# Access Compliance Report

## Public Rights-of-Way

### (Curb Ramps)

Intersection ID: N/A	Main Street: AGNEW_DR	Cross Street: VAWTER_RD	Location: SE
ADA ID: 7564E566CDE6	Ramp Type: Perp	Initial Pass/Fail: Fail	Overall Compliance: No
Codes/Mitigation Info/Possible Solution		Field Measurements/Component Compliance	
Severity Score: 13.75

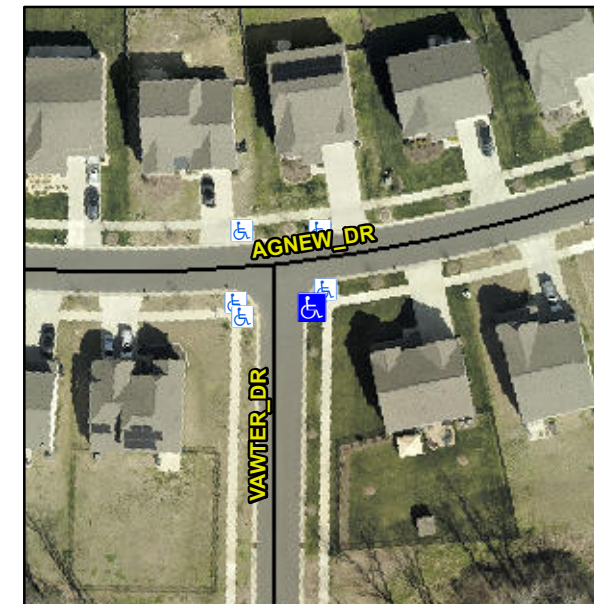
**Not Found, R304.2.2, R304.5.3**

Compliance	Description	Data	Compliance	Description	Data
N/A	Ramp Length (in)	96.0	No	Ramp Slope (%)	9.7
Yes	Ramp Width (in)	48.0	No	Ramp XSlope (%)	3.6
N/A	Flare Type LT	N/A	N/A	Flare Type RT	N/A
N/A	Flare Slope LT (%)	N/A	N/A	Flare Slope RT (%)	N/A
N/A	Flare Traversable LT?	N/A	N/A	Flare Traversable RT?	N/A
N/A	Landing Length (in)	N/A	N/A	DWS Provided?	N/A
N/A	Landing Width (in)	N/A	N/A	DWS Contrast?	N/A
N/A	Landing Slope (%)	N/A	N/A	DWS Length (in)	N/A
N/A	Landing X Slope (%)	N/A	N/A	DWS Full Width?	N/A
N/A	Landing Curb? (Y/N)	N/A	N/A	DWS Offset (in)	N/A
N/A	Shared Landing?	N/A			
N/A	Gutter Ponding?	N/A	N/A	Gutter Slope (%)	N/A
N/A	Gutter Lip Ht (in)	N/A	N/A	Gutter X Slope (%)	N/A
N/A	Painted X Walk1?	No	N/A	Painted X Walk2?	N/A
	X Walk 1 Direction	To W		X Walk 2 Direction	N/A
N/A	X Walk 1 Width (in)	N/A	N/A	X Walk 2 Width (in)	N/A
	X Walk 1 Slope (%)	1.4		X Walk 2 Slope (%)	N/A
	X Walk 1 X Slope (%)	2.8		X Walk 2 X Slope (%)	N/A

**Remove & Replace Entire Ramp.**
